DORIS MINE

**Responses to Technical Comments, Nunavut
Water Board**

**REVISIONS TO TMAC RESOURCES INC.
AMENDMENT APPLICATION NO.1 OF
PROJECT CERTIFICATE 003 AND WATER
LICENCE NO. 2AM-DOH1323**

December 2015

Figure 1: Water withdrawal and losses Doris Lake during Operations.

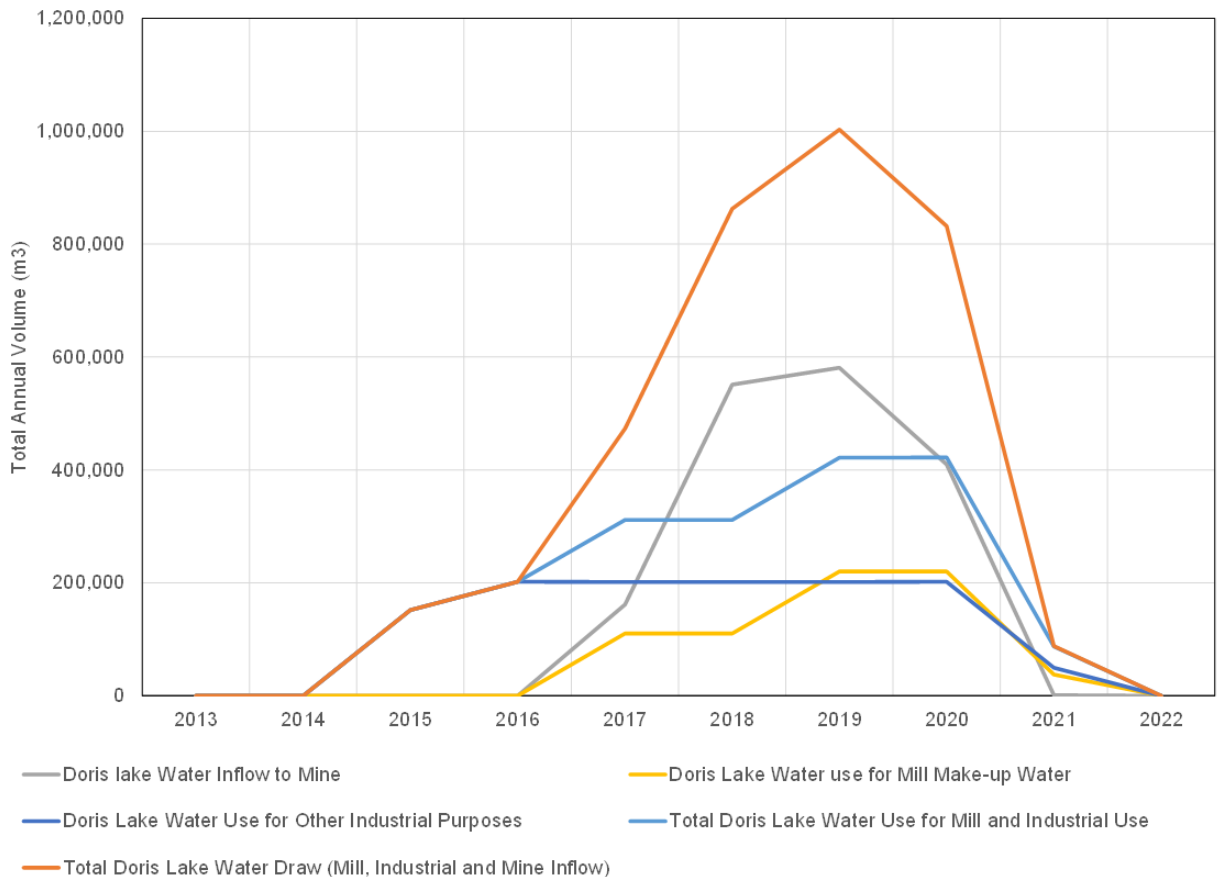
3.6 TMAC RESPONSE

The Doris North Project will use water from Doris Lake for Mill Make-up Water and other Industrial use as described in supporting document P6-10, Site-Wide Water and Load Balance Model. Figure 6-6 in Section 6.2.2 of that document graphically presents the mean Doris Lake inflows and outflows graphically. Figure 1 below, plots the same information but focuses on the period of active mining, and only presents the water withdrawals components as a result of the mining activities undertaken by TMAC. This demonstrates that the peak water draw from Doris Lake as a result of mill make-up

water and other industrial use is about 422,000 m³/year (blue line), and this occurs for only two years of operations.

Figure 1: Concentration of Total Dissolved Solids in 10WBW001 Zone 6

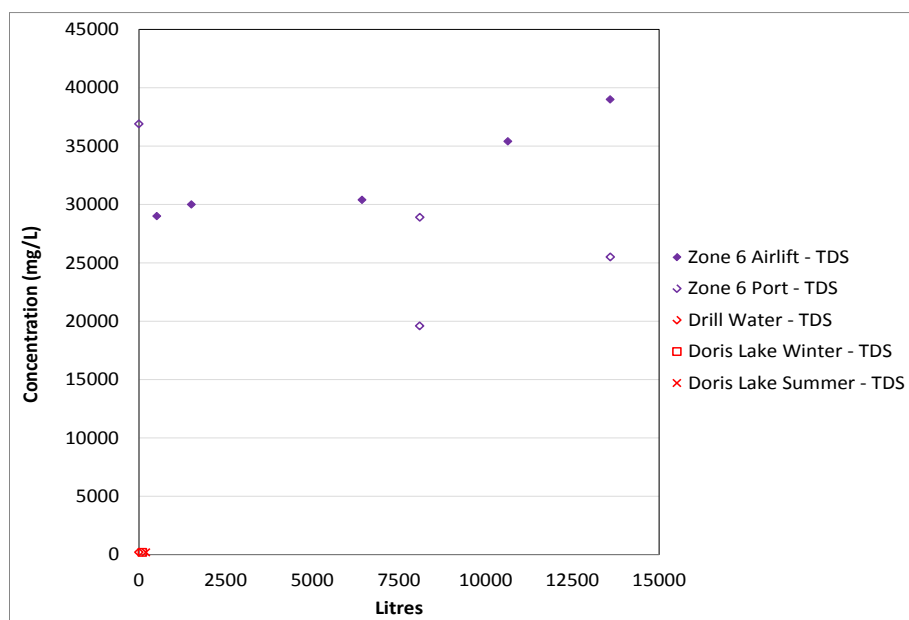
The Proponent's response to EC IR#6 states that 96 hour acute toxicity tests on 3-spine stickleback were completed in October of 2010. The test results are discussed, however, the laboratory results are not provided in the amendment application or in their response. It was also unclear whether the groundwater sample used for testing was an accurate representation of the anticipated groundwater quality that will be managed and discharged.

Recommendation/Request: Provide the laboratory reports on the ground water toxicity testing that was conducted in October of 2010. Discuss the location, depth and quality (provide chemical characterization analytical results) of the ground water sample used in the testing. Indicate what criteria were used to determine that the groundwater sample used was reflective of anticipated effluent quality. Discuss any additional testing that is proposed to assess the toxicity of "end of pipe" effluent.

The comparison of repeated samples over time indicated that variability occurs in natural concentrations of groundwater, some of which may be induced by the pumping and drawing in groundwater from locations further from the well, from the different sampling methods (airlift vs. discrete samples), and/or lab analysis methods (water vs. seawater analysis). Figure 1 shows the progressive changes in concentration of total dissolved solids (TDS) throughout the development, between 19,000 and 39,000 mg/L.
